ADDENDUM No. 3

April 6, 2016

Little Sisters of the Poor Main Street Renovations  
601 Maiden Choice Lane, Baltimore MD 21228

Project No: 15046.00

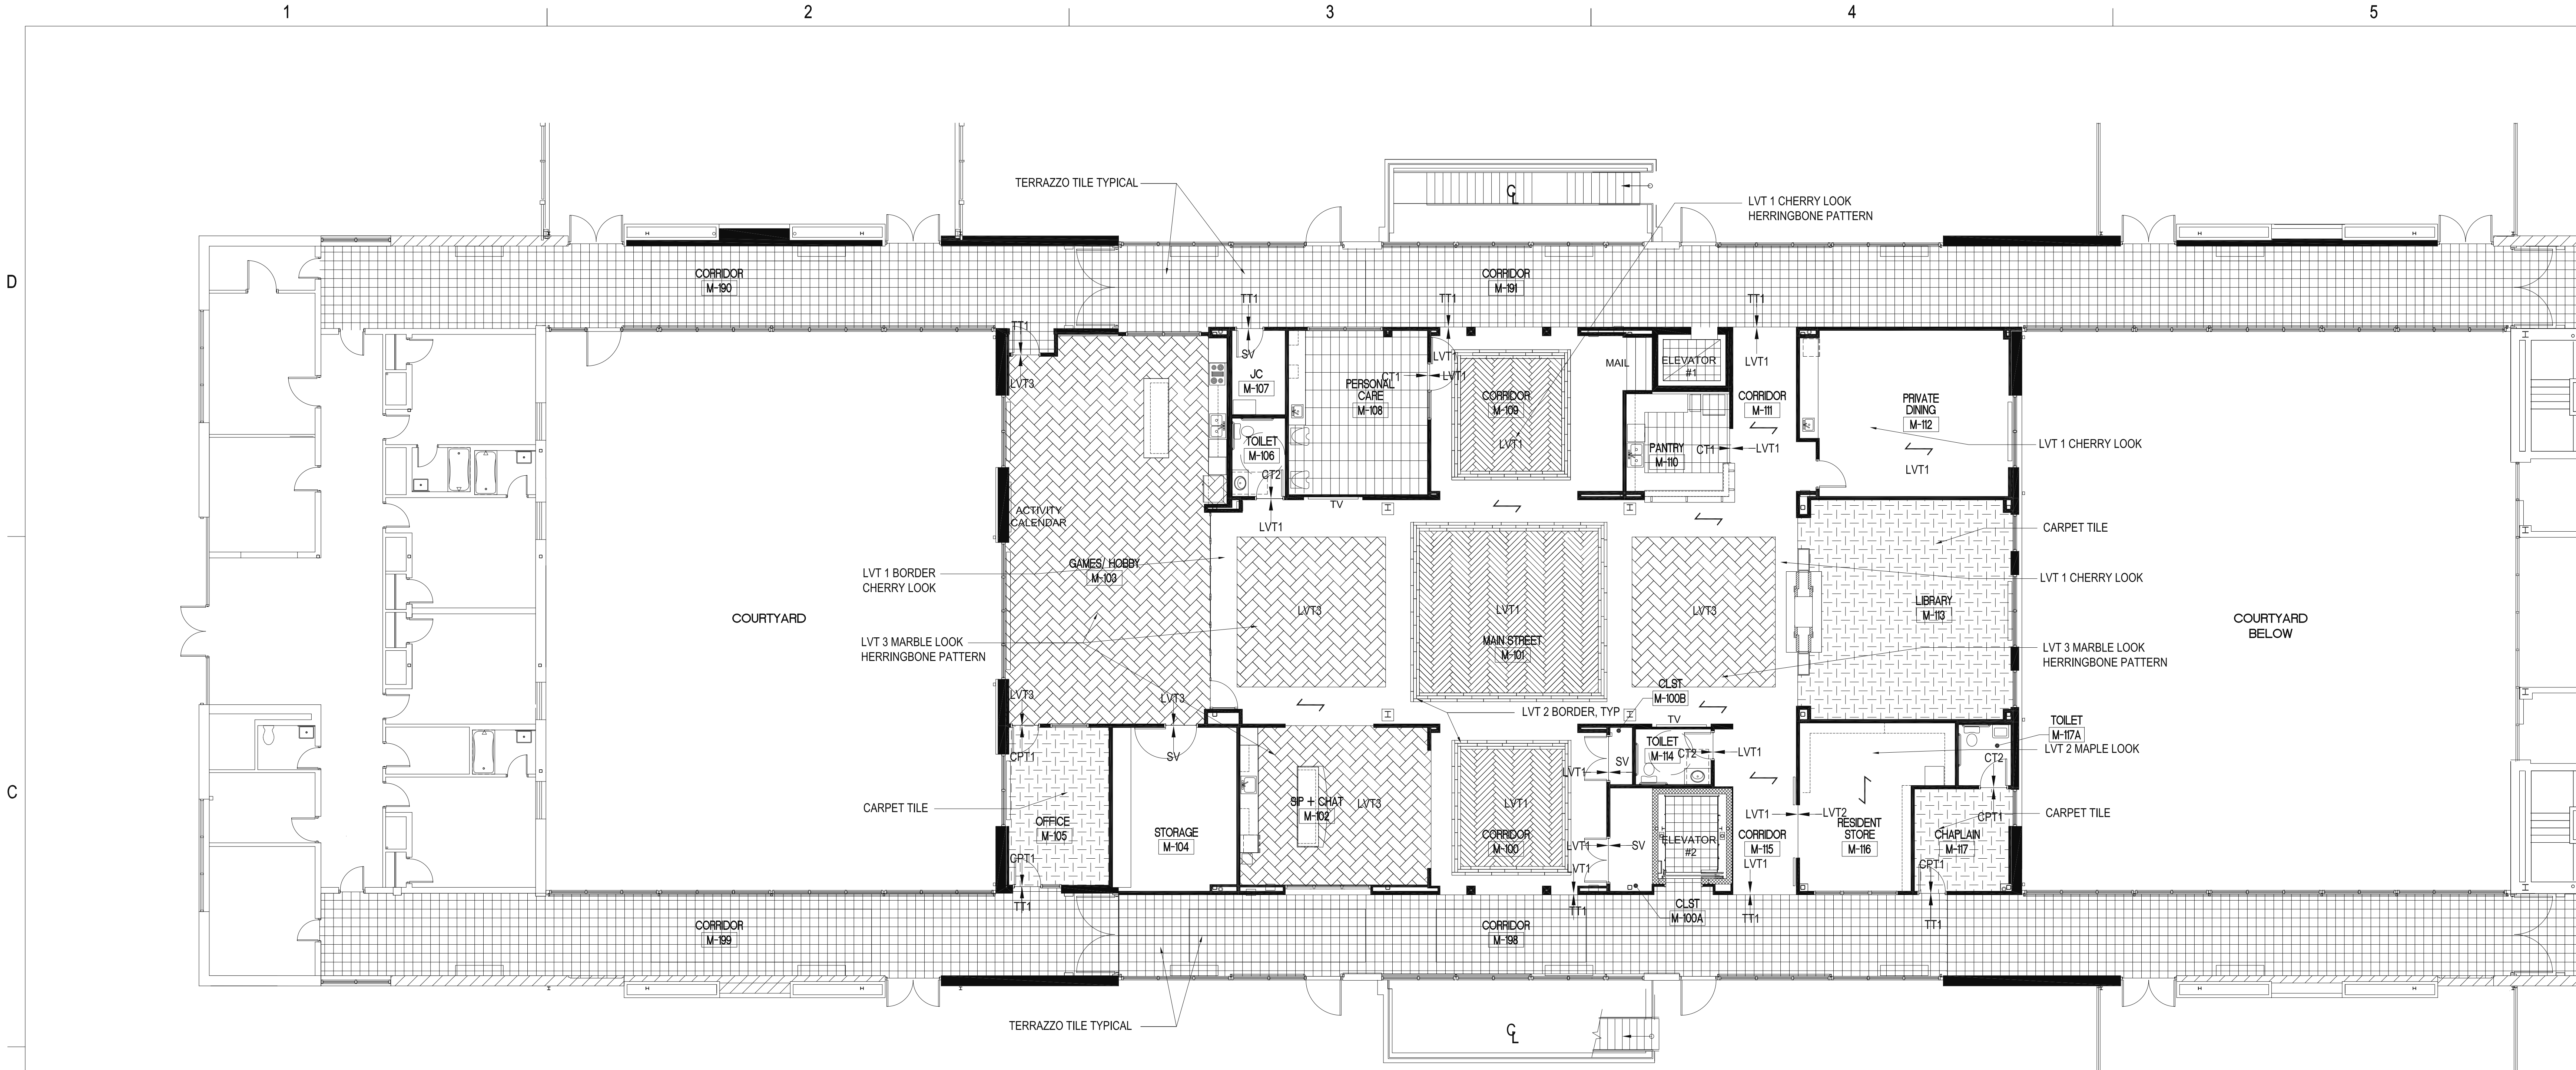
1. Drawing E-111: see revised drawing for updates as follows:
  - a. New Partial basement plan for new elevator scope.
  - b. Added Specific notes related to the Elevator.
2. Drawing E-501: see attached sketch E-SK-501-01 for update to the Electrical Riser diagram
